CITY OF TONTITOWN PLANNING OFFICE

Meeting: **March 26, 2019**
Project: **Morsani Acres**
Planner: Courtney McNair

- i. **Planned Unit Development (PUD) REQUEST**
- ii. **PRELIMINARY SUBDIVISION PLAT REQUEST**
- iii. **WAIVER REQUEST**

PRELIMINARY LARGE SCALE DEVELOPMENT PLAN APPROVAL REQUEST

PUD - MASTER STREET PLAN
MORSANI ACRES SUBDIVISION
TONTITOWN, AR

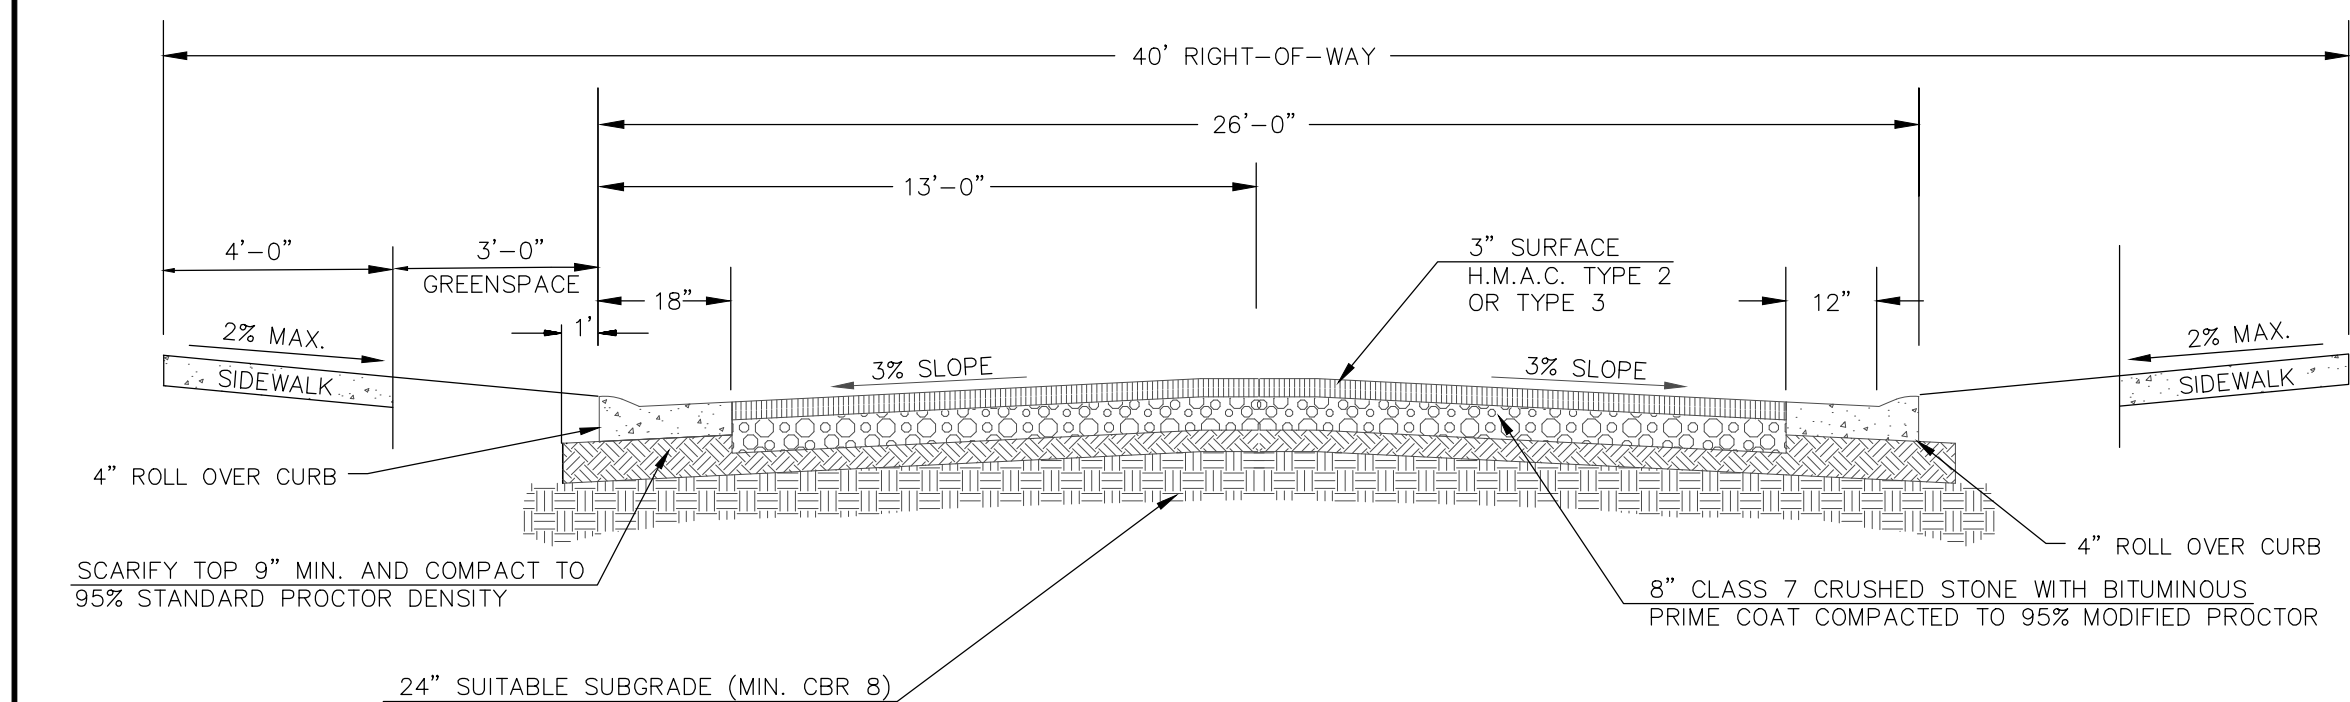
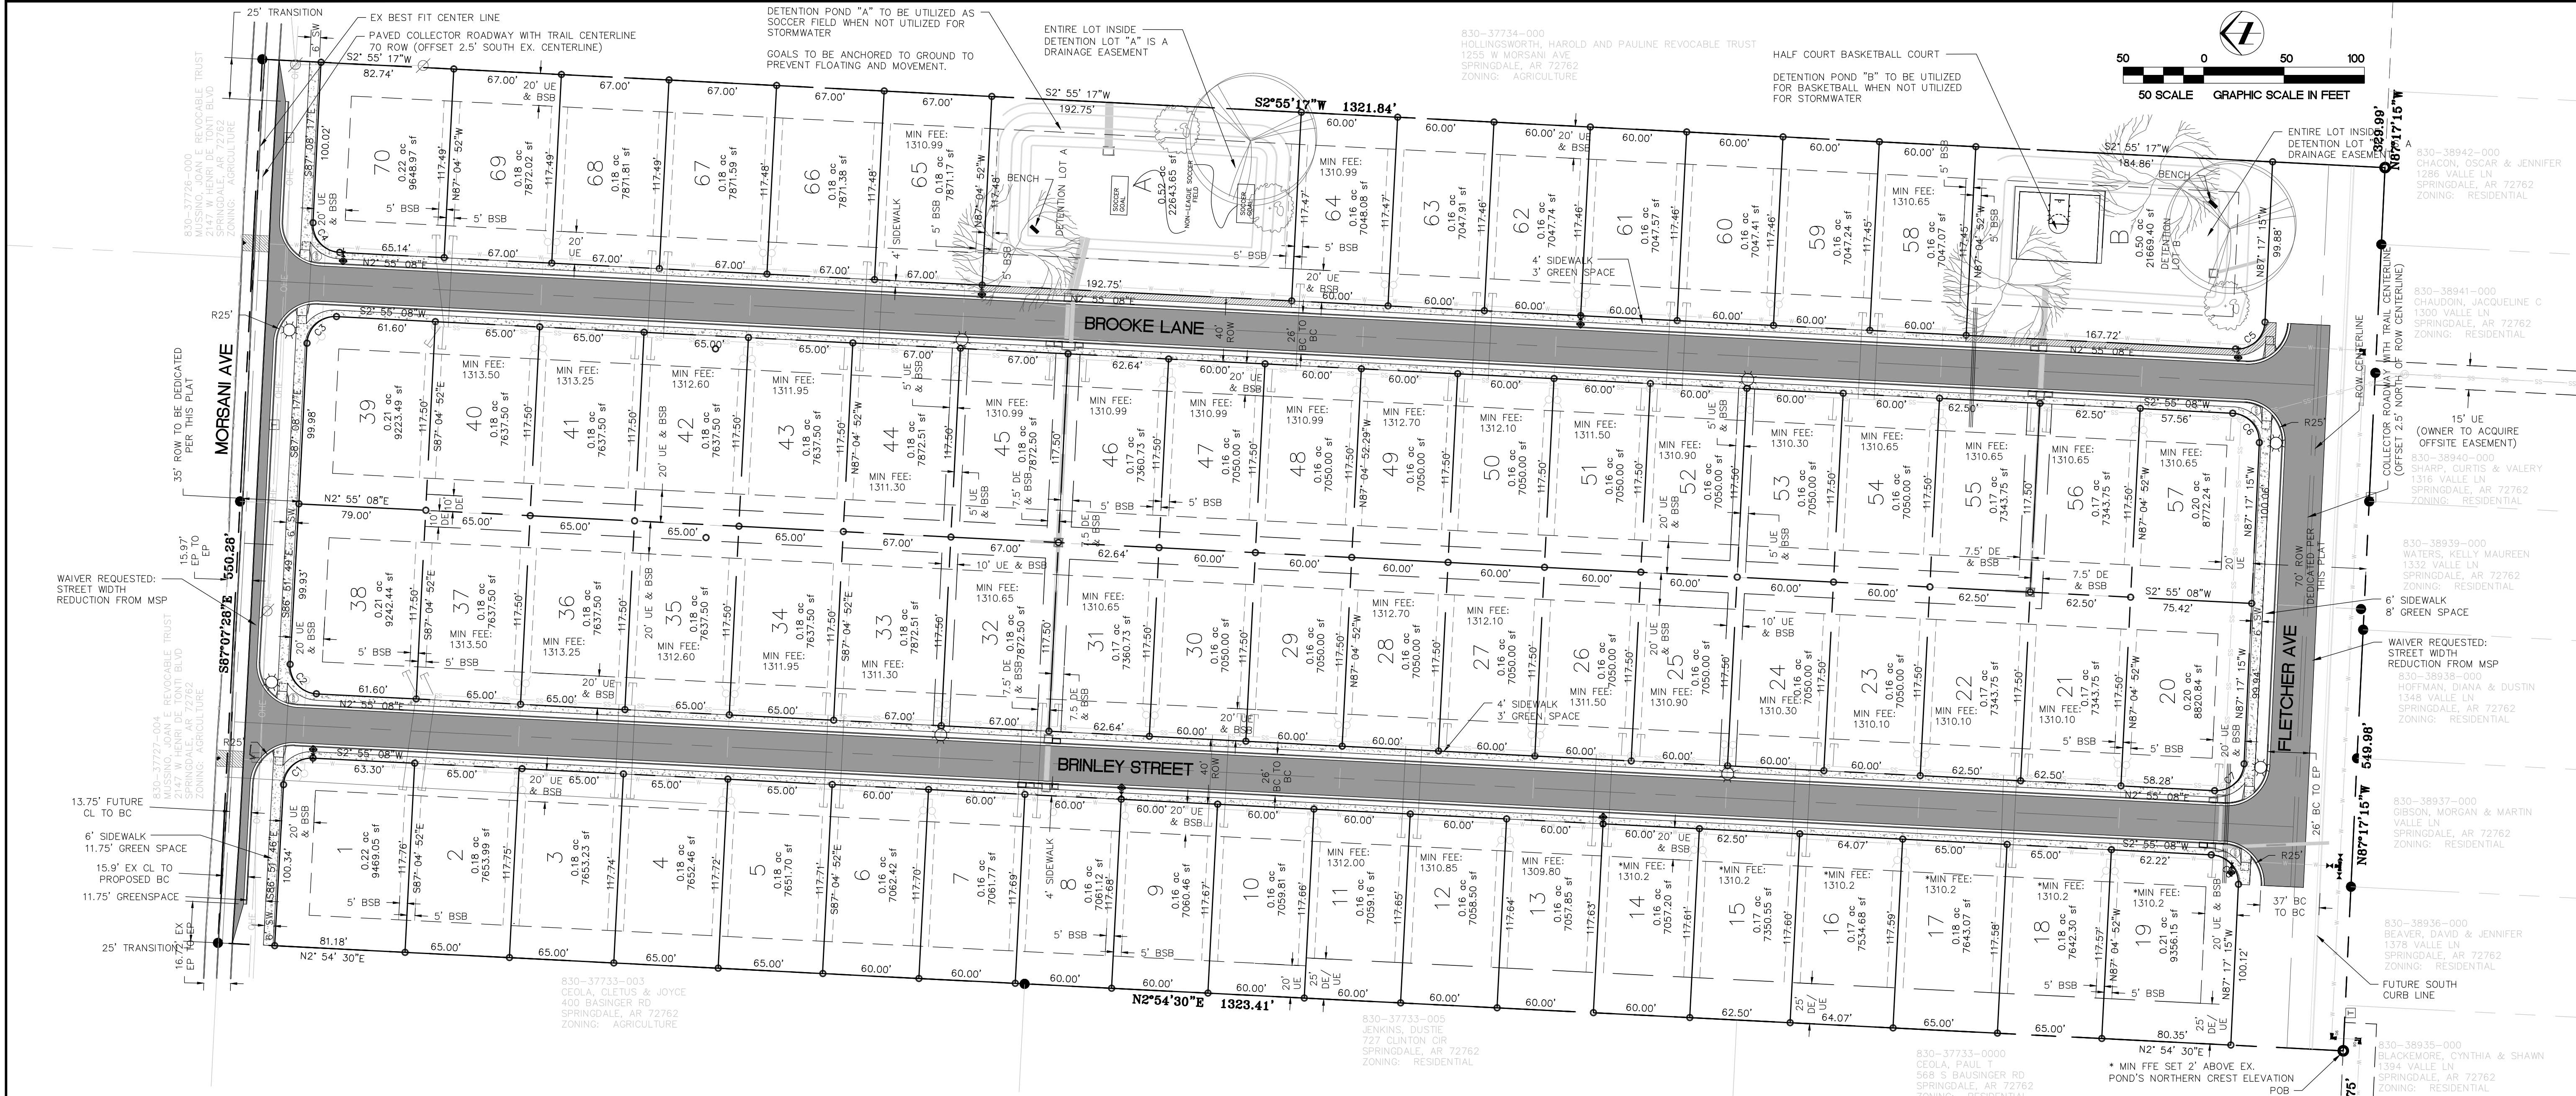
We are requesting a Waiver from code 90.400.4 90.400.4 and from any other portions of the code requiring the street improvements from which this Waiver is requested. The Waiver request is from some of the required road improvements along Fletcher Ave. south of the proposed Morsani Acres Subdivision. The submitted plan shows the full 70' Right of Way (ROW) to be dedicated for future extension of W. Fletcher Ave. Specifically, it is road improvements for the southern lane and the far east and western sides from which this Waiver request applies.

Currently, Tontitown's Master Street Plan (MSP) shows W. Fletcher Ave. extending straight eastward across Bausinger Rd. along the southern property line of the proposed Morsani Acres Subdivision. A number of extenuating circumstances exist for this request. Due to lack of ROW dedication with Hidden Valley Estates subdivision to the immediate south, the ROW dedication has been requested by the city to shift north by 35 ft. This will place the entire 70' right of way on this project instead of being shared between properties. This will also put a 35 ft. northward jog in the future Fletcher extension. Since Fletcher Ave.'s full extension has not been designed yet, the manner in which this jog will have to take place can't be known. Therefore, we are proposing the eastern and western stub-outs to not be developed. This is to give additional distance to realign the road to the original-proposed location. Lastly, the road section width the developer would be required to construct per code requirements of 90.400.4 - typically this requires the developer to construct their half of the road. However, in this case half of the road is only 18.5' and that width does not meet fire code requirements. We are proposing improving 26' of this section of Fletcher Ave's width – curb and gutter, sidewalk, and road improvements for the northern lane between lots 20 and 75. This would accommodate turning around of vehicles and emergency personal and would hopefully prevent the City of Tontitown from having to tear out some of the road when the jog and connection to Bausinger Rd. is constructed in the future. We

We would like to officially withdraw the waiver request from street improvements for Morsani Ave. We will revise the plans to show the road widening as required on the Master Street Plan.

PRELIMINARY PLAT
MORSANI ACRES SUBDIVISION
TONTITOWN, AR

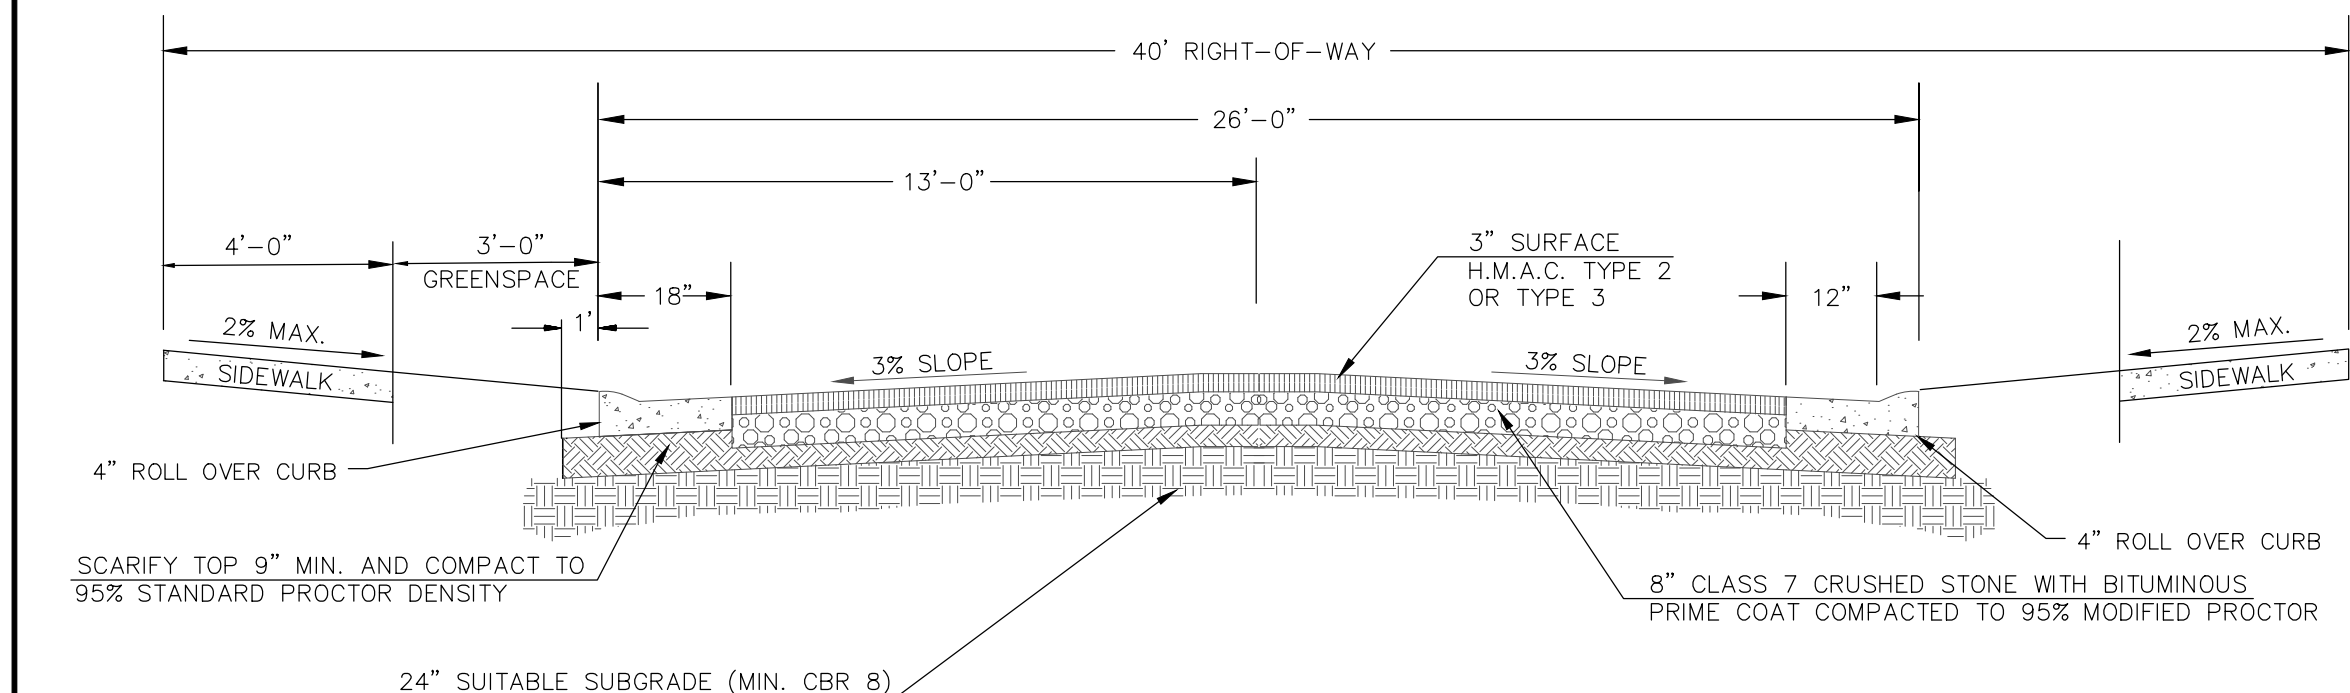
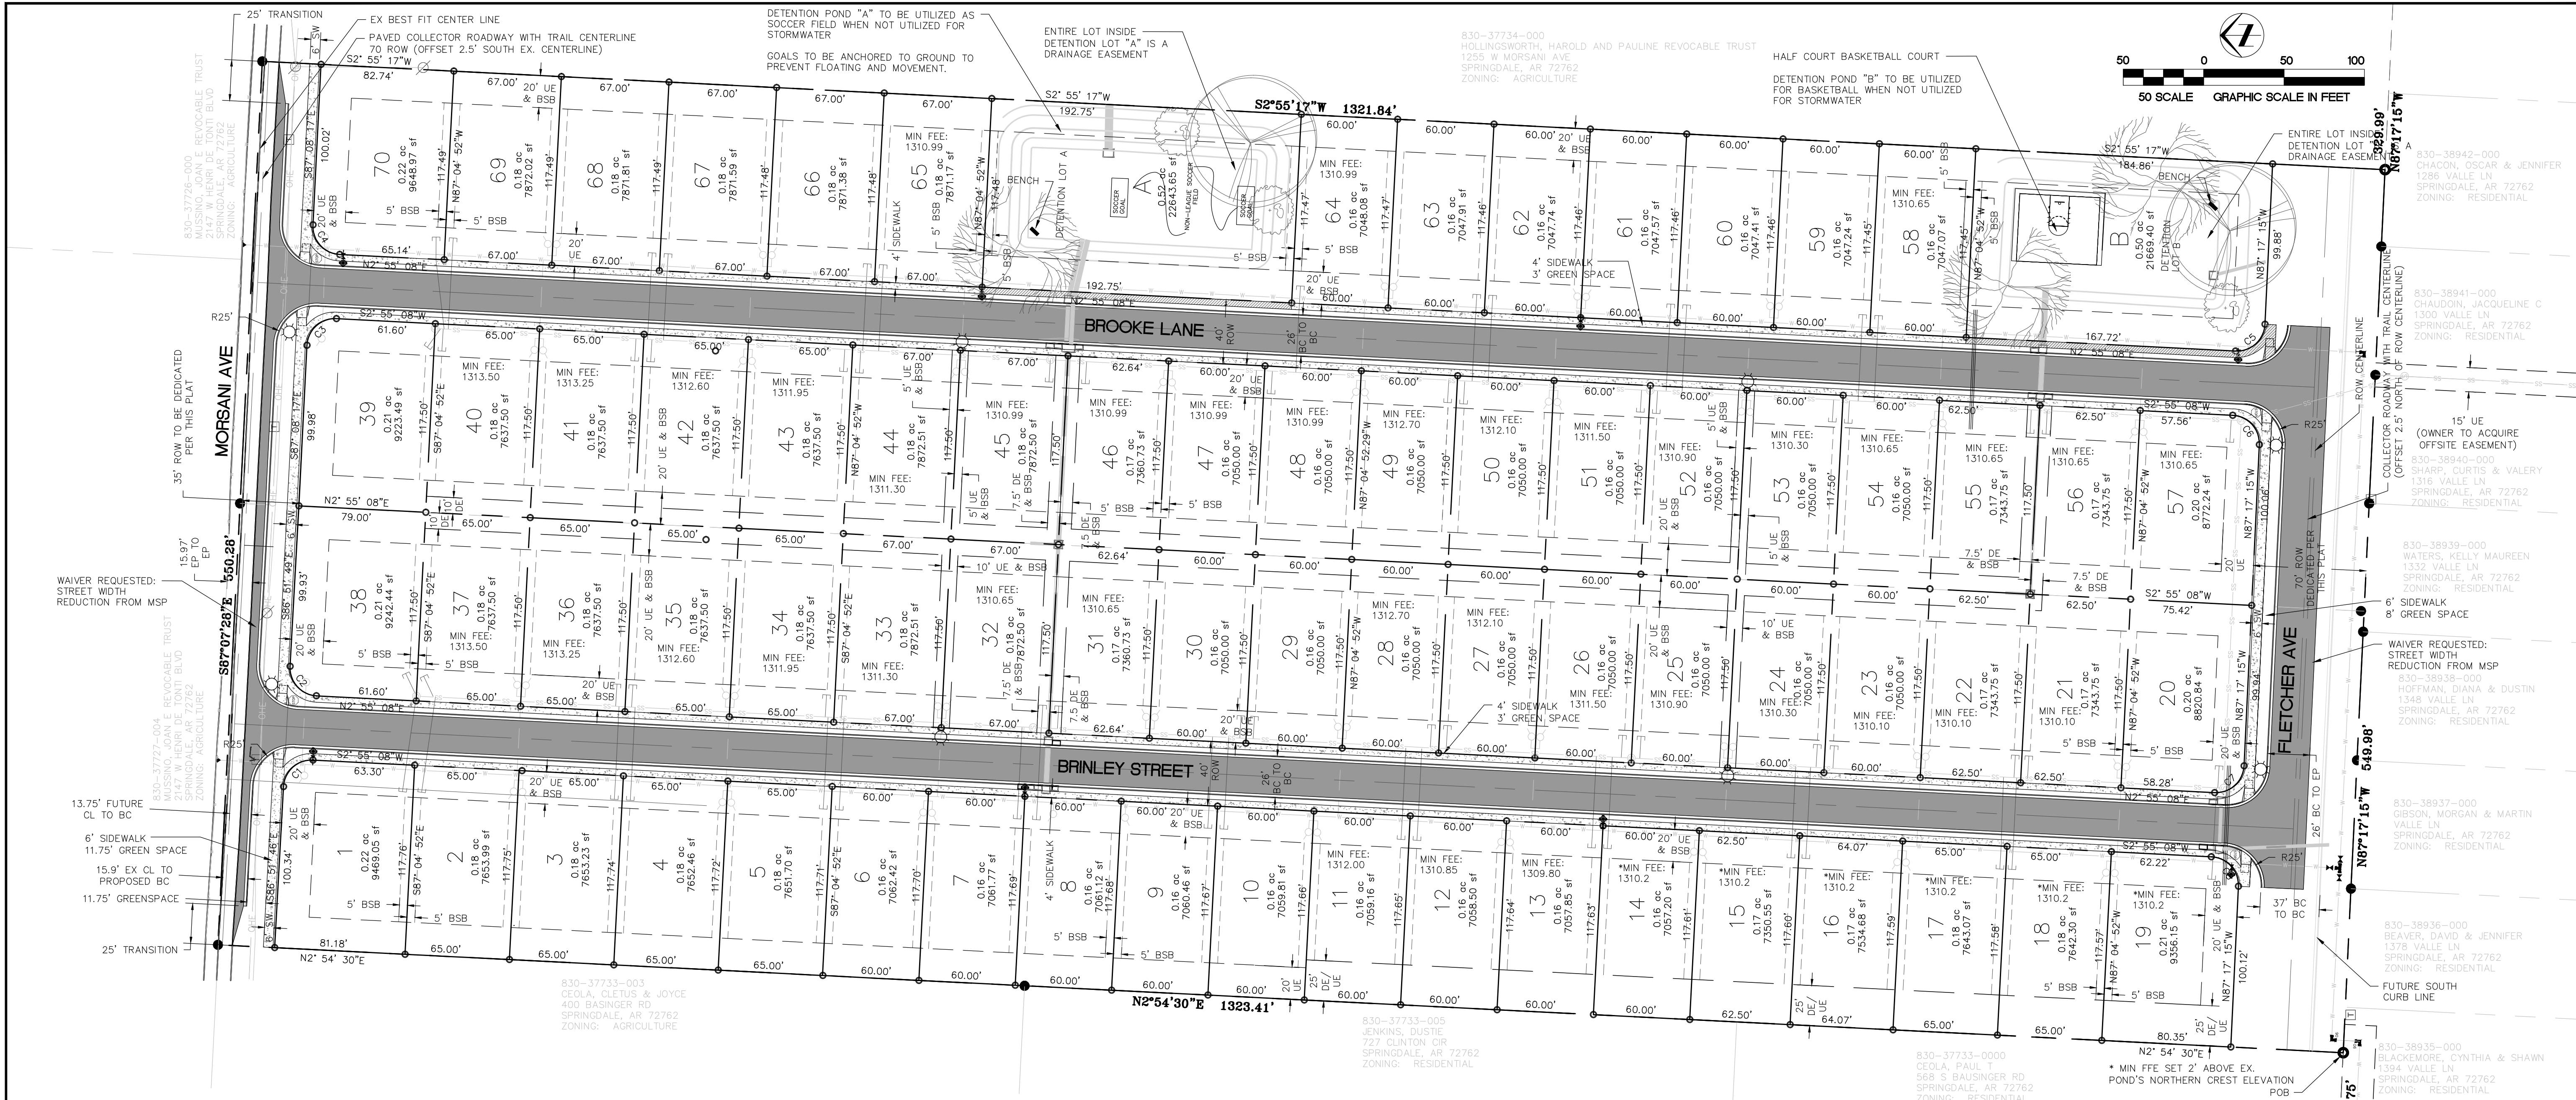
The interior streets are proposed to be 26-feet wide with no parking on the street. It is the applicant’s responsibility to provide the “no parking” signage. This street section is wider than the smallest street section allowed by the City (20-feet with bump outs at hydrants to 26-feet). The applicant did not want the street to feel overly constrained. Sidewalks are shown on both sides of the streets.

As this is a PUD, the applicant has provided park areas to be located with the detention areas. They are providing a basketball court (half), soccer goals, and park benches along with landscaping to benefit the community. Sidewalks are proposed to provide access internally to these areas.

Lot sizes in this development meet PUD requirements and the Future Land Use Plan for this area. They range from 7048 SF to 9469 SF with the larger lots along Morsani Road and Fletcher Road.
